Project	IEEE 802.16 Broadband Wireless Access Working Group < http://ieee802.org/16 >	
Title	Architecture clarification and Coexistence Protocol messages cleaning	
Date Submitted	2005-09-14	
Source(s)	Chi-Chen Lee, Hung-Lin Chou, Industrial Technology Research Institute, Computer and Communications Research Labs, Taiwan Bldg. 11, 195 Sec. 4, Chung Hsing Rd. Chutung, HsinChu, Taiwan 310, R.O.C.	Voice: +886-3-5914579 Fax: +886-3-5829733 mailto: jjlee@itri.org.tw
Re:	Call for Contributions: IEEE 802.16 License-Exempt Task Group, IEEE 802.16h-05/018	
Abstract	Propose the architecture of storage of identification information and Coexistence Protocol.	
Purpose	Information.	
Notice	This document has been prepared to assist IEEE 802.16. It is offered as a basis for discussion and is not binding on the contributing individual(s) or organization(s). The material in this document is subject to change in form and content after further study. The contributor(s) reserve(s) the right to add, amend or withdraw material contained herein.

Architecture clarification and Coexistence Protocol

[Figure 14. Classification of 802.16 LE network architecture](#)

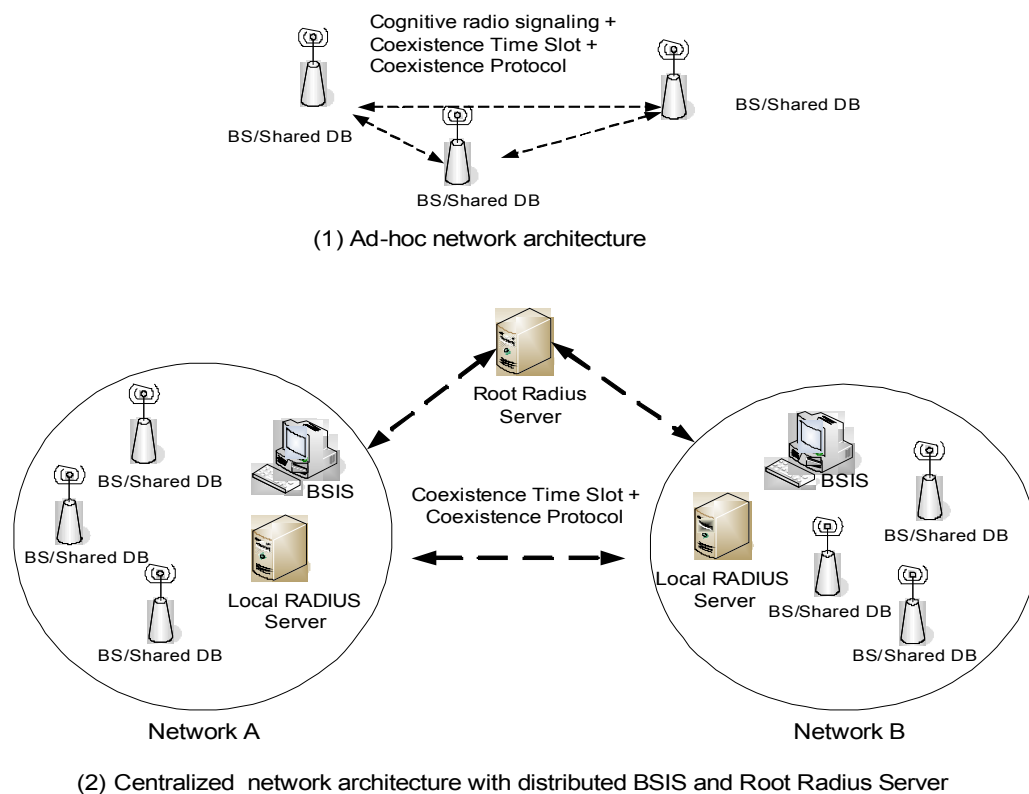
[Change Figure 14 as following]

[Figure 14 shows the classification of IEEE 802.16 LE inter-network communication architecture:](#)

Figure 12. Initialization procedures — BS

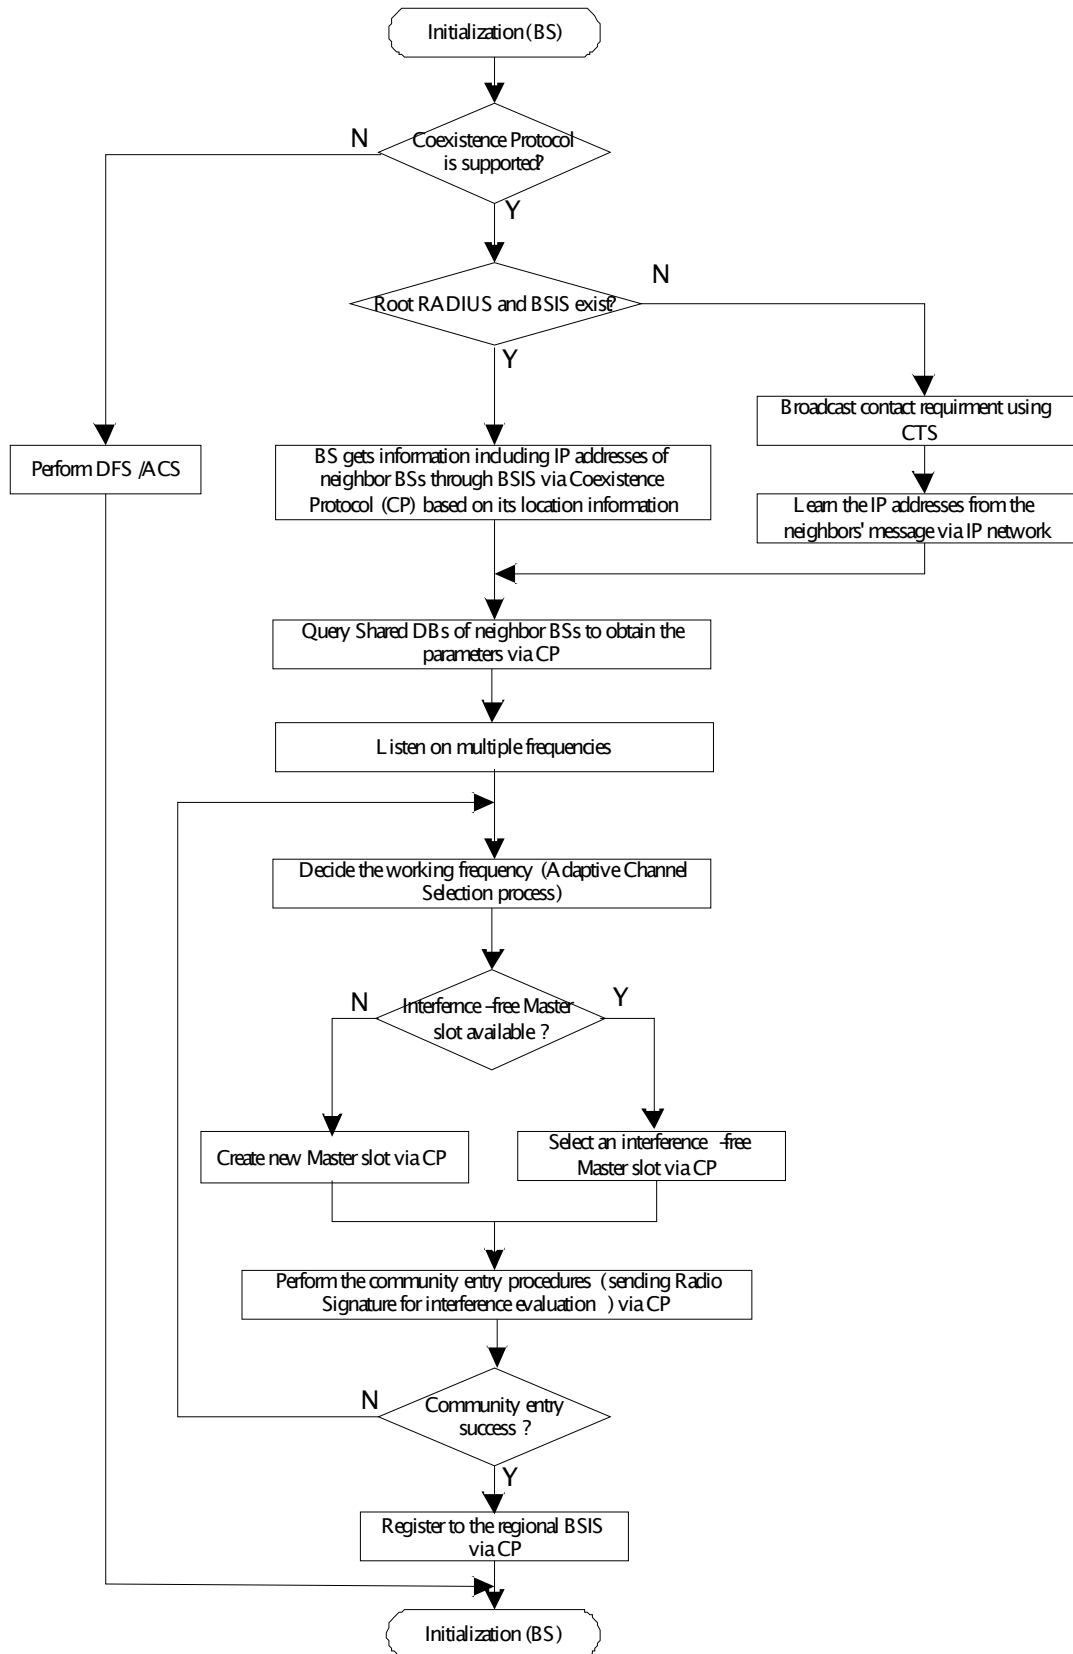
[Replace Figure 12 as following]
